**Subject: Responses to Comments to Request for Approval of Design Exception
CSSFT-0008-00(314) Pickens County
P.I. Number: 0008314
SR 136 from SR 136 Connector to SR 515
GS&P Project No. 24643.05**

Subject: Revised Request for Approval of Design Exception
CSSFT-0008-00(314) Pickens County
P.I. Number: 0008314
SR 136 from SR 136 Connector to SR 515
GS&P Project No. 24643.05

DRAWING No.
16-01

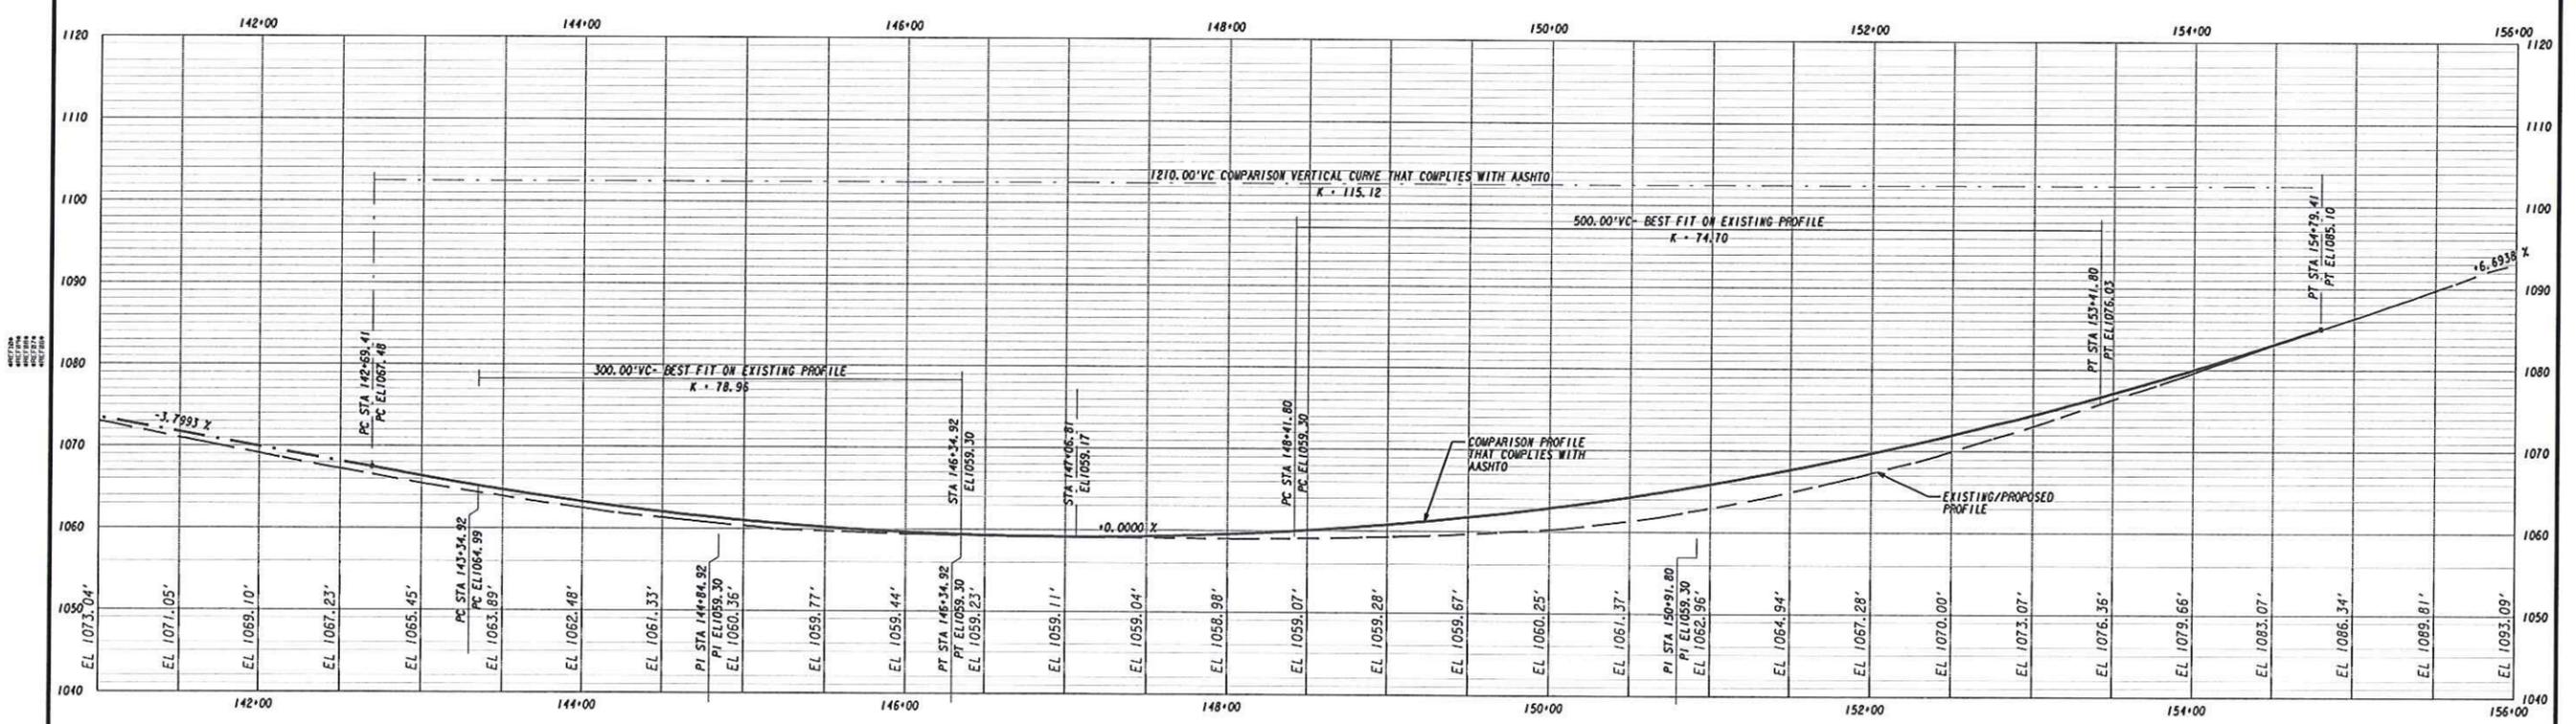
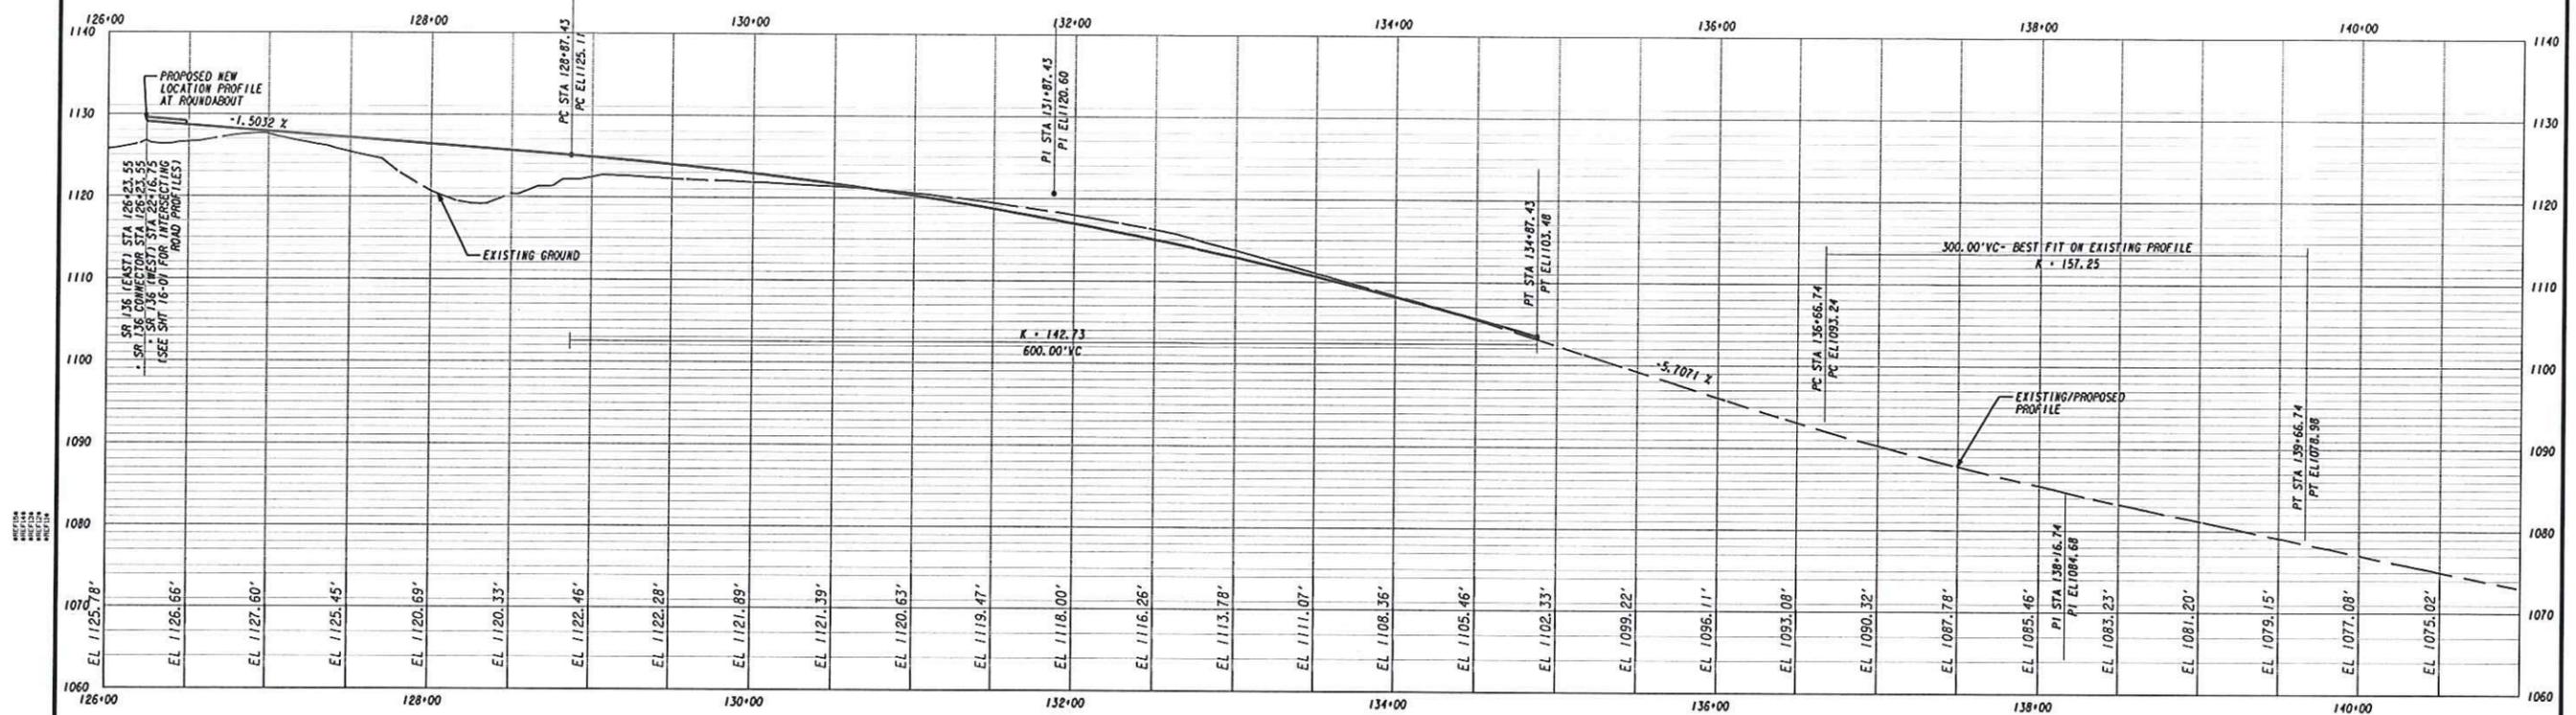
9. *Page 15-01, the profile sheet does not show the profile tie to existing on the west side of STA 126+00. Please provide the related profile sheet to show how the entire extent of the proposed project profile ties to existing.*

The extended profile sheets for all three legs of the proposed roundabout at SR 136 and SR 136 Connector has been included in the revised request. Please see sheet 16-01.
